Piping Design Review

In early 1982, The Cleveland Electric Illuminating Company (CEI) conceptually defined the scope of a Design Verification Program. This was done to further our confidence in the Gilbert Associates, Inc. (GAI) design program and our recognition of the regulatory environment and its changing direction.

This report, Piping Design Review, represents one portion of that overall effort which includes design review programs addressing both Quality Assurance and Engineering objectives.

The Cyqua Energy Consultants were selected to perform the piping design review on selected systems, as described in Part I, Section 1-3. This review was completed as of February 28, 1984. The methodology of the review is described in Part I Section 4.0 and Part II Volume I, Section 3. The results and all documentation from the review are contained in Part II Volumes 1 & 2 of this package.

FIGURE 1

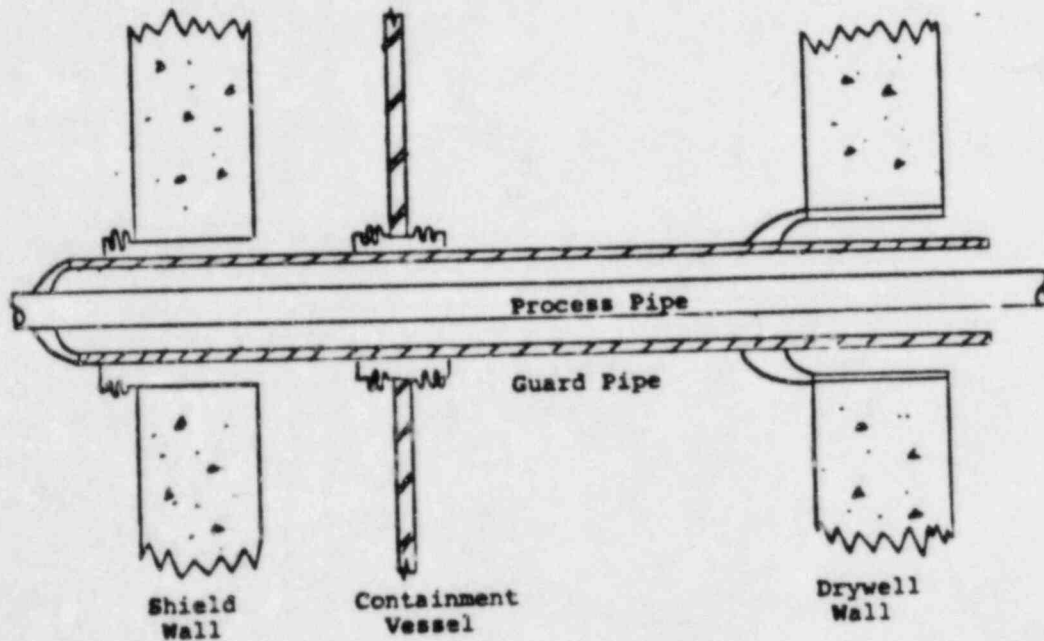
*The actual moment arm shown on the vendor drawing is 14.90 in.
